# Manor Road Richmond Design and Access Statement Landscape Addendum 03

November 2021 / P11559-00-001-708-01

# Landscape Addendum

LANDSCAPE MASTERPLAN - AMENDED PROPOSED DEVELOPMENT

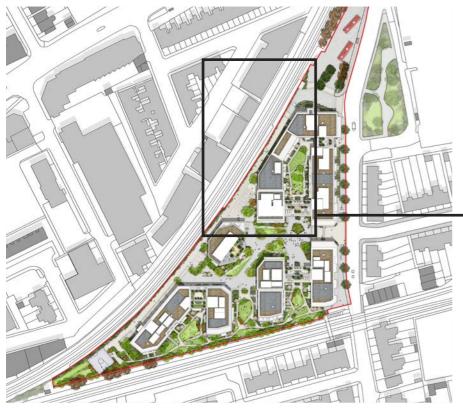
- 1. Application boundary amended to align to title plan.
- 2. Car club bays relocated from western boundary as a result of change in red line
- 3. Accessible parking bays moved as a result of shift in car club bays
- 4. Refuse holding area relocated from western boundary as a result of change in red line
- 5. Courtyard design reconfigured to make up for loss of play space as a result of shift of refuse holding area
- 6. Minor amendments to landscape layout at South East corner as a result of change in red line

DETAIL OF PARKING AREA- NOVEMBER 2021 AMENDMENTS

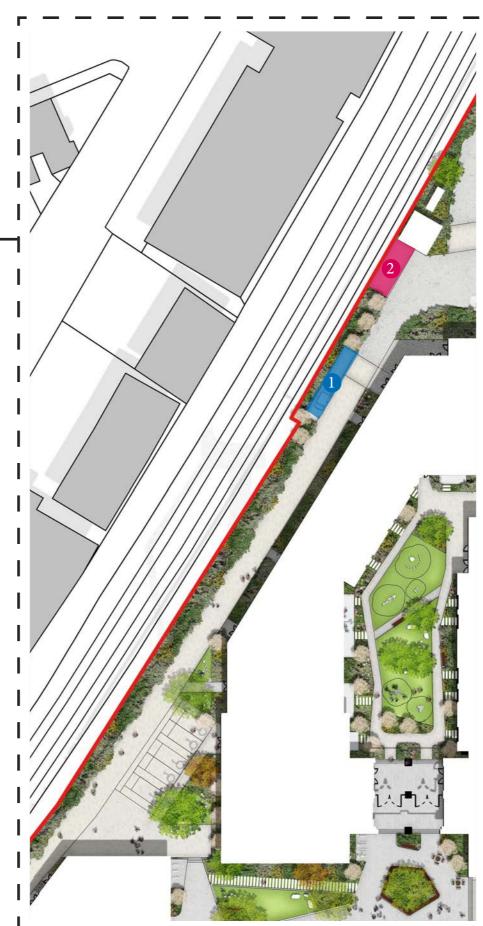
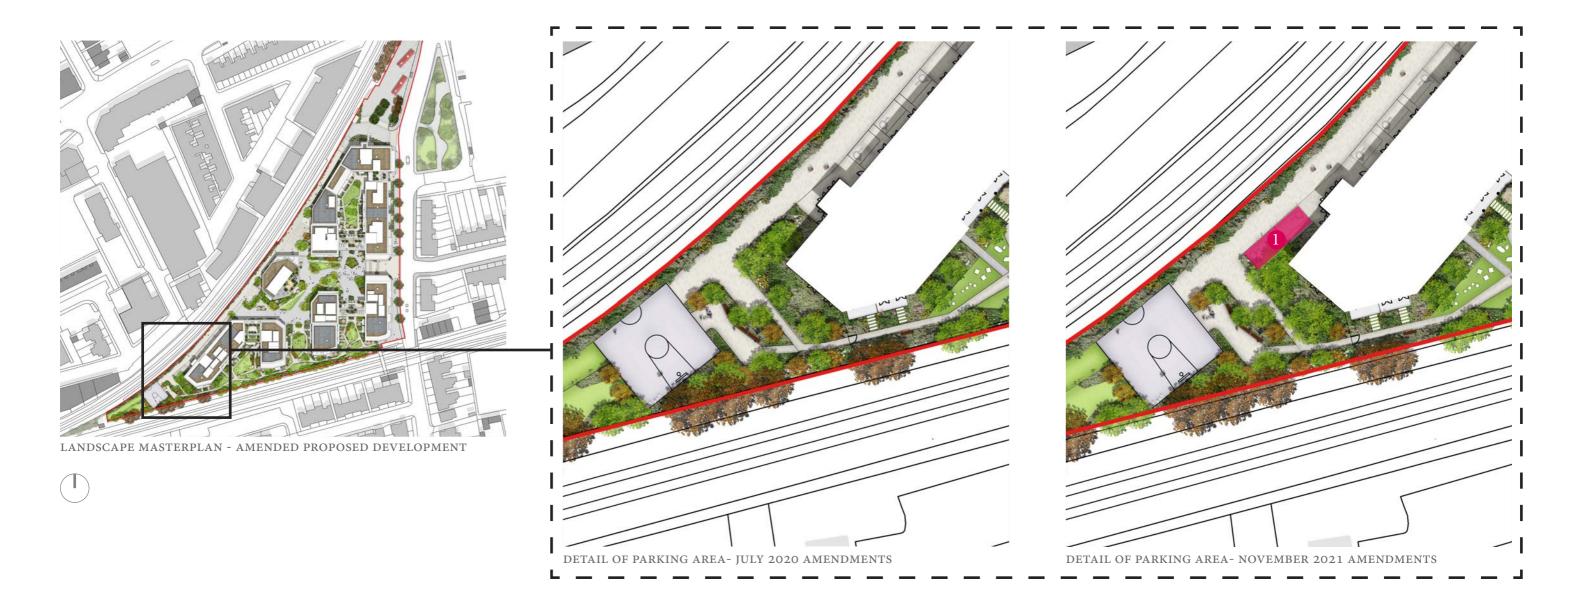
- 1. 2no. car club bays relocated from western boundary to parking area north of Block B in place of 2no. accessible parking bays
- 2. Refuse holding area relocated from wetsern boundary to area north of Block B in place of doorstep play space
- 3. Reduction in planting along boundary

Reprovision of 2no. accessible parking bays displaced by car club bays. Note: proposed trees affected have been relocated elsewhere meaning no reduction in overall number of trees within the development

PLAY STRATEGY PLAN

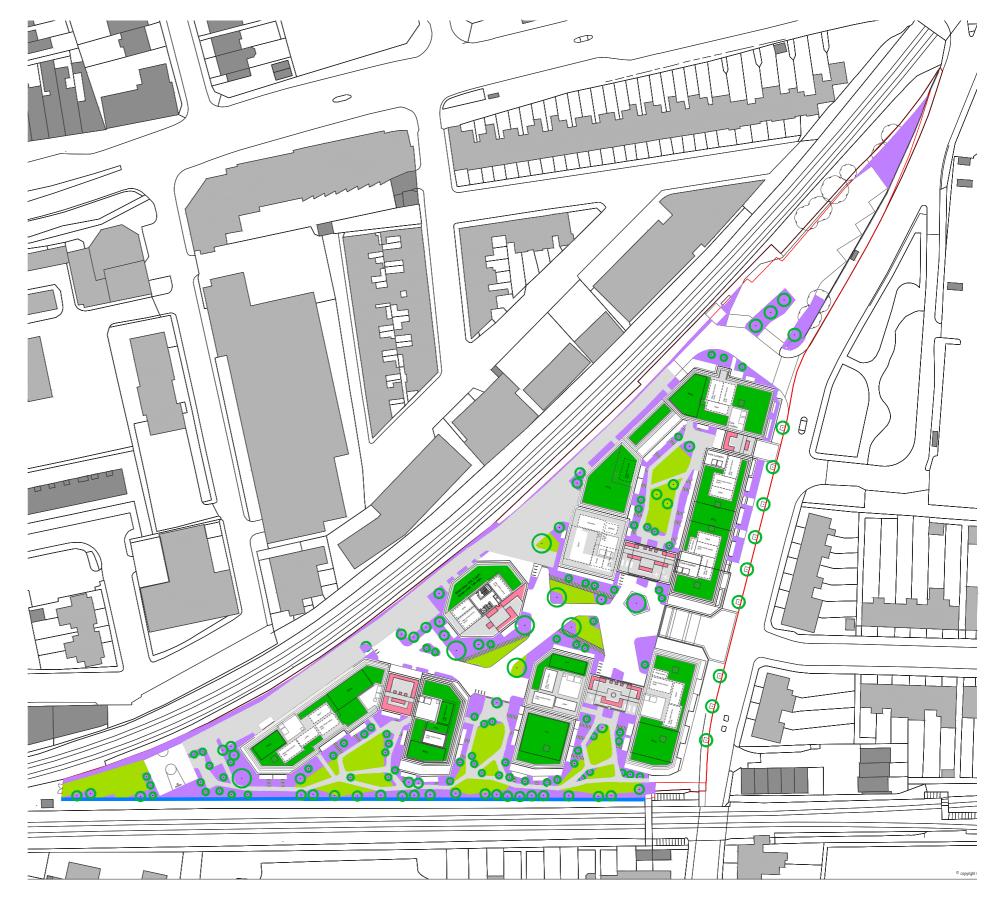
The relocation of the refuse holding area impacts on doorstep play provision along the western access. As described on the previous page, this is reprovided through reconfiguration of the south eastern courtyard meaning no overall change in play provision from the previous submission.

URBAN GREENING FACTOR PLAN

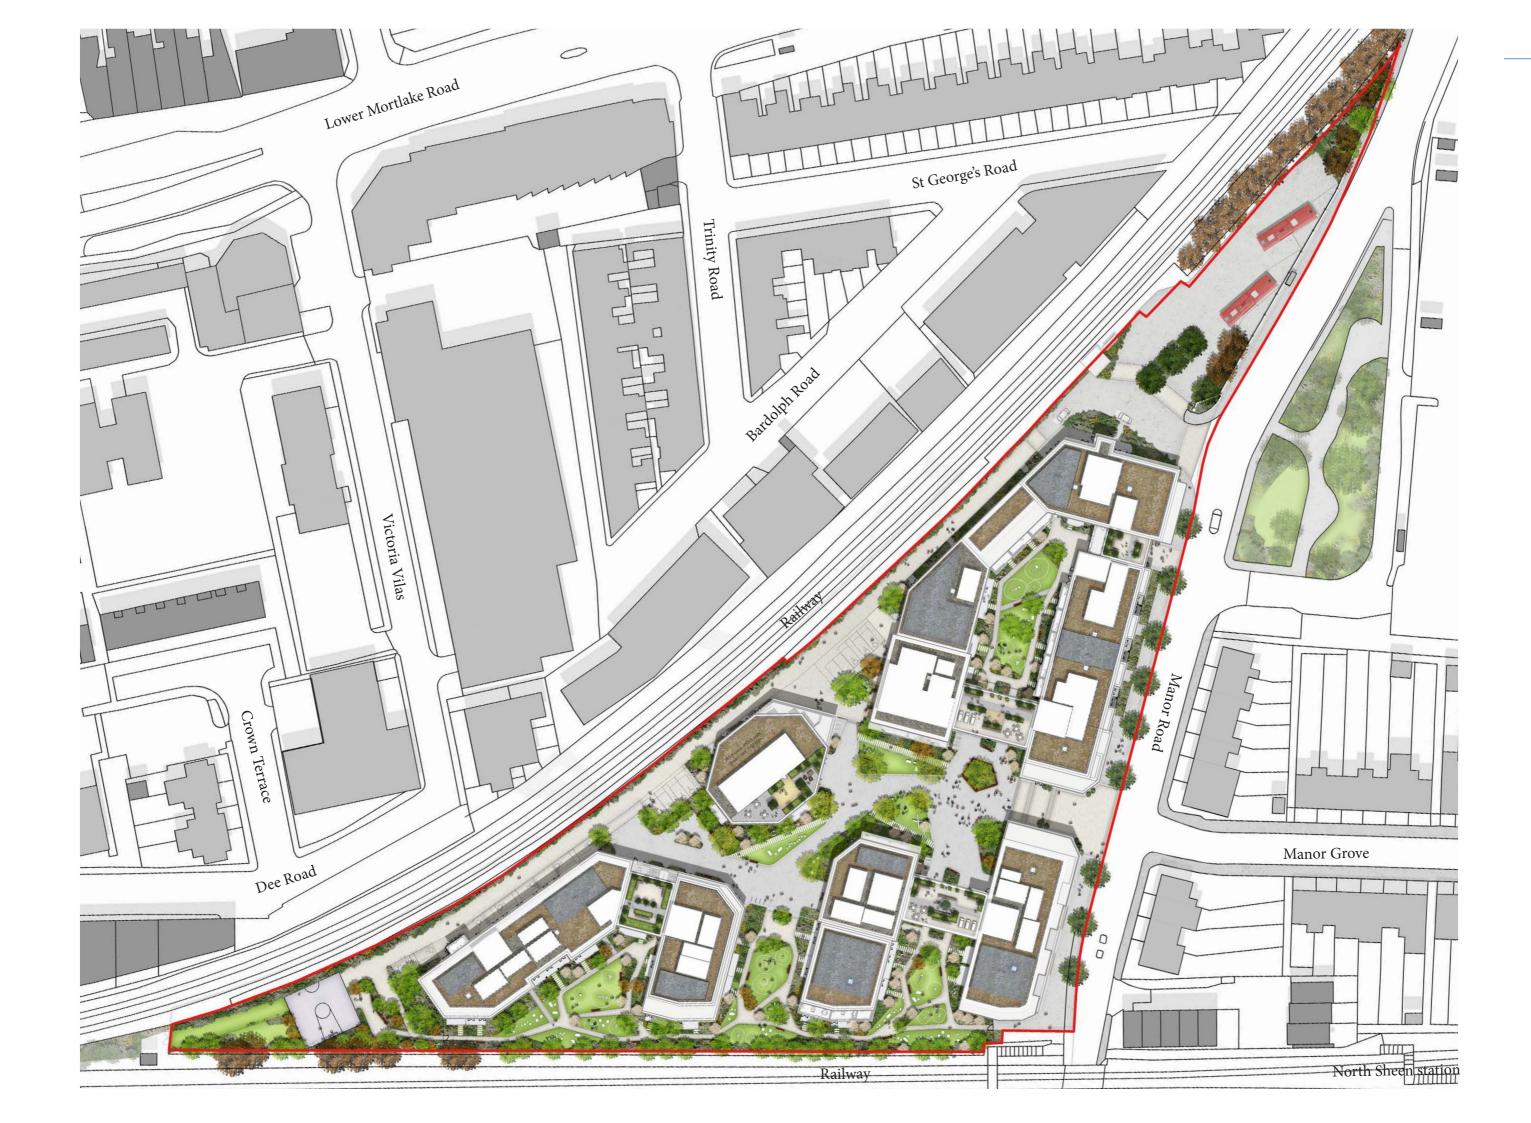
The Amended Proposed Development July 2020) scheme gave a UGF score of 0.32. Incremental loss of planted areas with the reduction in red line area impacts on the score in the revised proposals. This has been mitigated by the following design changes:

- Percentage of flower rich perennial planting within proposed mixed ornamental planting is increase to approx. 60%
- Climber planting is now proposed along the southern boundary wall to mitigate for loss along western boundary

This results in a revised UGF score of 0.31
